SERVICE BULLETIN

Replacement of fuel pumps for ROTAX® Engine Type 912 (Series)

ATA System: 73-00-00 Fuel system

Replacement of fuel pumps for ROTAX® Engine Type 912 (Series)

Fig. 1

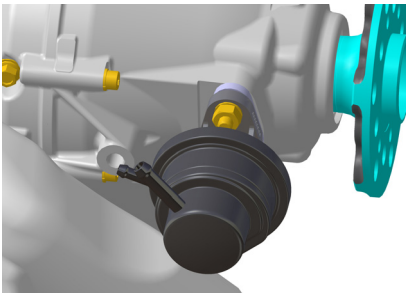
3.1.1) Removal of fuel pump part no. 892542 (without crimped hose assembly), see [Fig. 1](#)

Step	Procedure
1	Remove fuel hoses as per aircraft manufacturers instructions. NOTE: Make note of orientation of the hoses (inlet/outlet).
2	Loosen hex. nuts (13 mm/0.51 in) and remove fuel pump with lock washer A8 and insulating flange (gasket).

Fig. 2

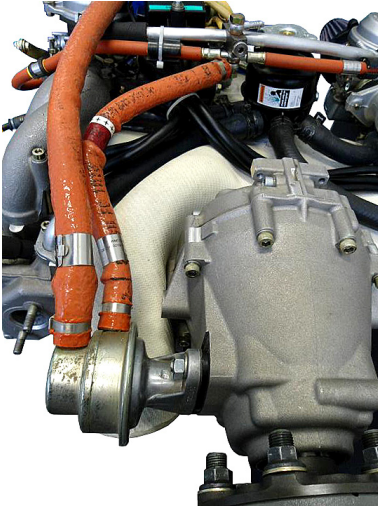
3.1.2) Removal of fuel pump part no. 892546 (with fire sleeve), see Fig. 2

Figure shows fuel pump part no. 892546 with crimped fuel hose assy. and fire sleeve.
Fuel pump

Fig. 3

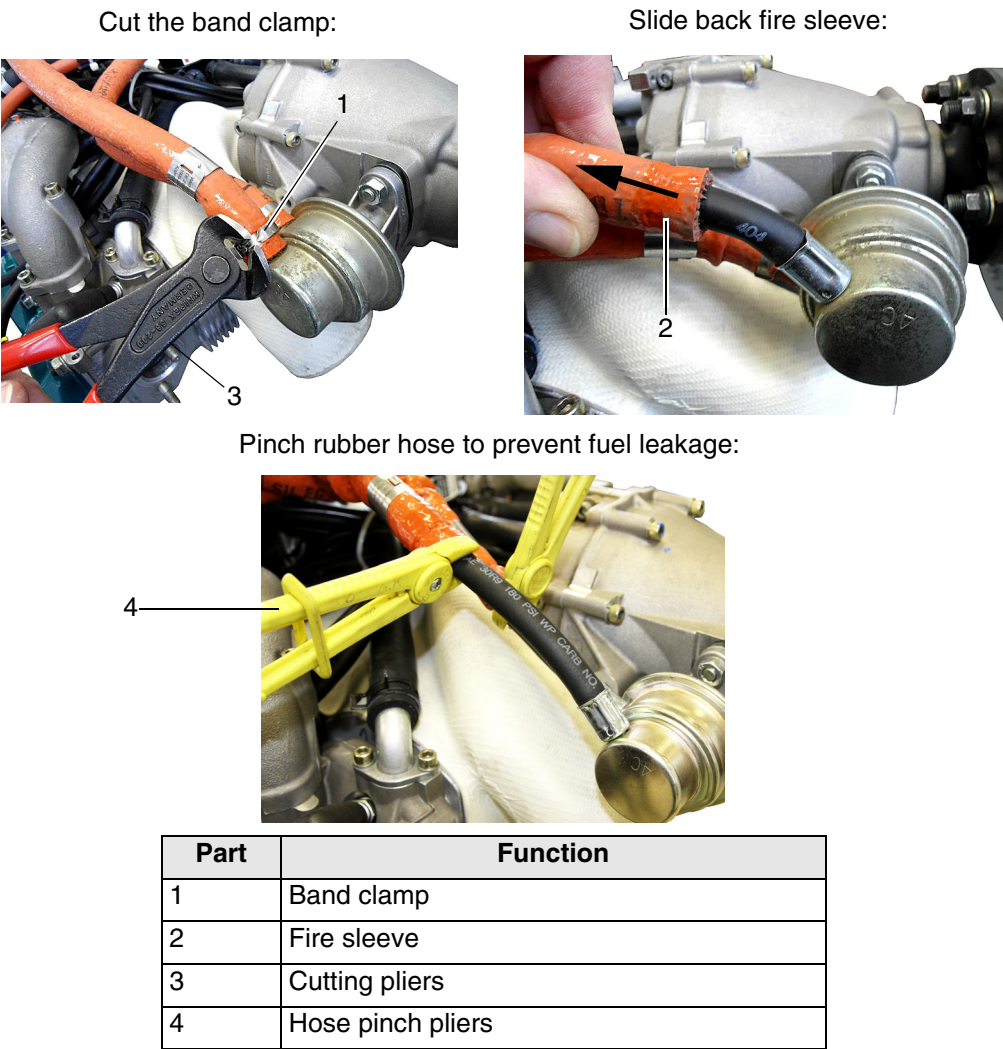
The following work steps are necessary (see Fig. 3):

Step	Procedure
1	Cut off the 1-ear clamp (1) of fire sleeve (2) with cutting pliers (3).
2	Slide back the fire sleeve (2) to make fuel hose accessible for cutting.
3	Pinch off the fuel hose with hose clamp pliers (4).

Fig. 4

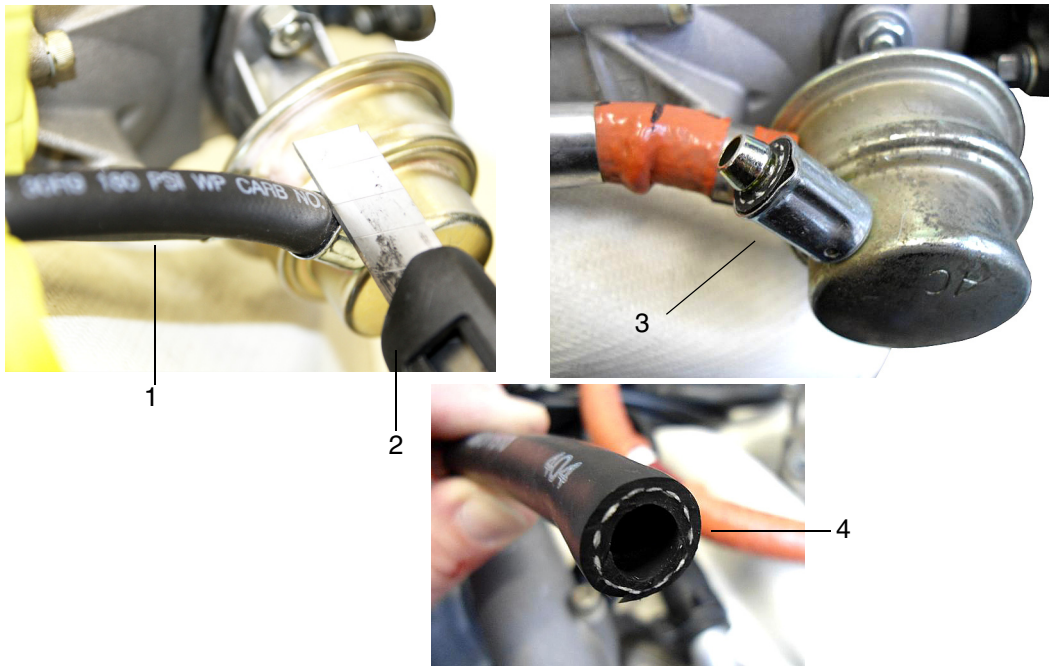
NOTE: Cut off the fuel hose with a very sharp knife, so that no cutting residues are produced. See Fig. 4.

Step	Procedure
4	The cut should be made adjacent to the crimped ferrel, to avoid losing any needed length. The fuel hose is reduced by approx. 20 mm (0.79 in.). NOTE: Make note of orientation of the hoses (inlet/outlet) A clean cut surface is very important!
5	Repeat procedure at the second fuel hose assy.

Fig. 6

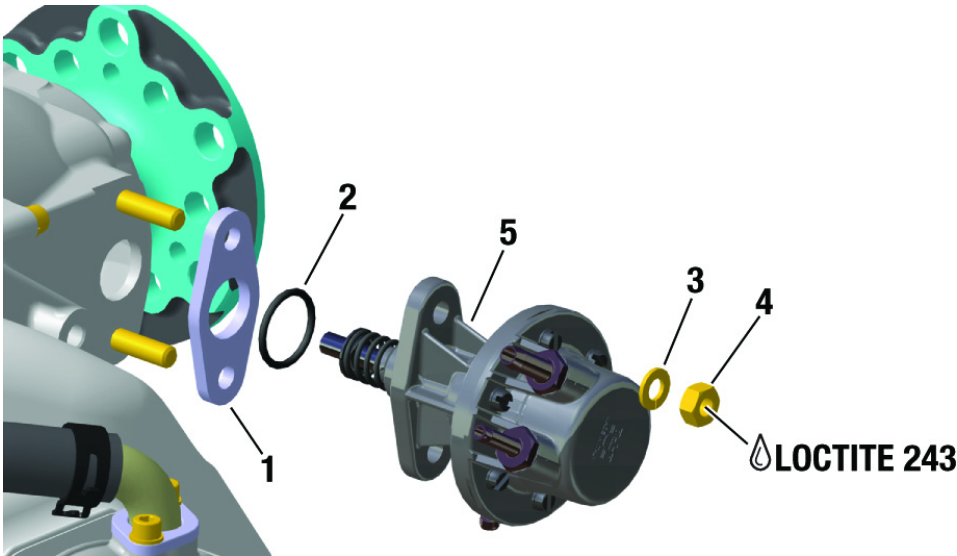
See Fig. 6.

In addition to the insulating flange (gasket) also replace the O-ring at reassembly or assembly of the fuel pump.
Both parts are included in the set of fuel pump assy.

Ensure the O-ring is located in the recess in the fuel pump, before installing the fuel pump!

Step	Procedure
1	Install fuel pump (5) with new insulating flange (gasket) (1) and O-ring (2).
2	Secure new hex. nuts M8 (4) and lock washer A8 (3) with LOCTITE 243 and tighten them evenly. Tightening torque 15 Nm (133 in.lb).

Fig. 7

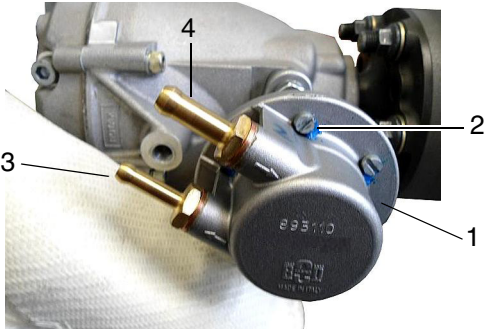
See Fig. 7.
The fuel pump cover (1) must not be opened for inspection. Check the security markings (witness paint) (2).
Check the connecting nipples (3)+(4) for tightness. If necessary secure them with LOCTITE 243.
Tightening torque 10 Nm (88.5 in.lb).
- Graphic

Step	Procedure
1	Connect the hose from the fuel tank to the connecting nipple identified as 4 in Fig. 7.
2	The hose that goes to the carburetors should be connected to the connecting nipple identified as 3 in Fig. 7. NOTE: After installation of the hoses ensure the fuel tap is turned back ON.

Fig. 8

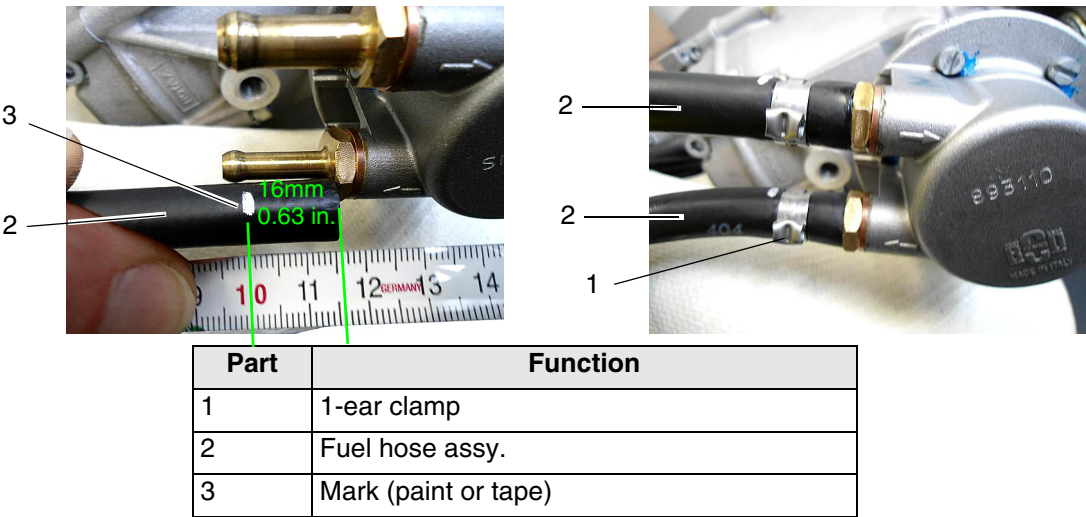
See Fig. 8.

Step	Procedure
2	Before the fuel hose (2) is fitted with a 1-ear clamp (1), the two fuel hoses have to be marked (3) 16 mm (0.63 in.) from the end of the hose (2).
3	Slide all 4 1-ear clamps (1) on the fuel and fire sleeves. NOTE: Clamps part no. 853313/851663 on fire sleeve and clamps part no. 851463/851453 on fuel hose.
4	Slide the fuel hoses (2) onto nipple completely up to the end stop.
5	Crimp 1-ear clamp (1)- outlet side part no. 851463 with suitable crimp pliers . NOTE: The edge of the 1-ear clamp (1) must align with mark (3) from fuel hose (2) , because otherwise there is too little space for the 1-ear clamp (1) of the fire sleeve.
6	Repeat steps on inlet-side with 1-ear clamp (1) part no. 851453 for fuel hose assy. (2).

Fig. 9

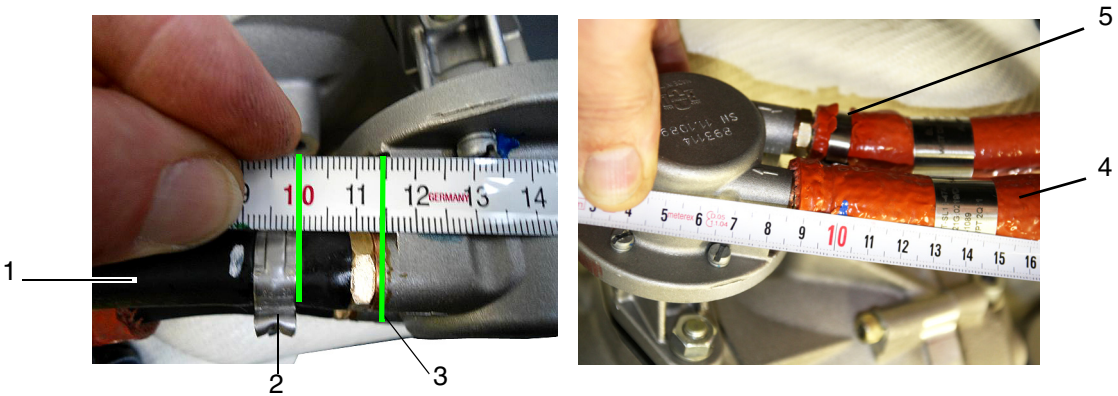
See Fig. 9.

The distance from the 1-ear clamp (2) to the nipple flange (3) has to be measured, so that the outer 1-ear clamp (5) can be mounted on the fire sleeve (4) in the correct position.

Step	Procedure
1	Measure the distance at fuel hose assy. (1) from 1-ear clamp (2) to nipple flange sealing surface (3) and mark the fire sleeve (4) correspondingly. NOTE: The clamp securing the fire sleeve should be as close as possible but without impeding on the fuel hose clamp

Fig. 10

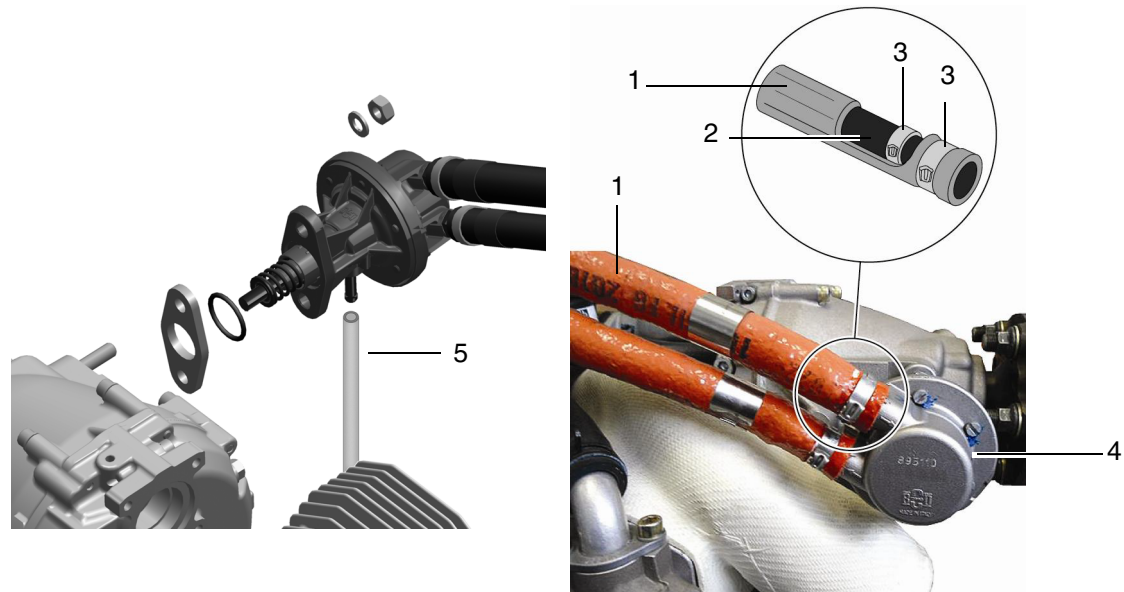
See Fig. 10.

Step	Procedure
2	Push fire sleeve (fuel inlet) to stop and mount 1-ear clamp (17.8-21.0 mm/0.70-0.83 in.) with suitable crimp pliers.
3	Repeat steps for fire sleeve (fuel outlet) (22.4-25.6 mm/0.88-1.01 in.).

A drain line must be installed, that in the event of a internal leak any fluid is drained to a suitable location/position. See therefore Installation Manual of the relevant engine type and SI-912-020.
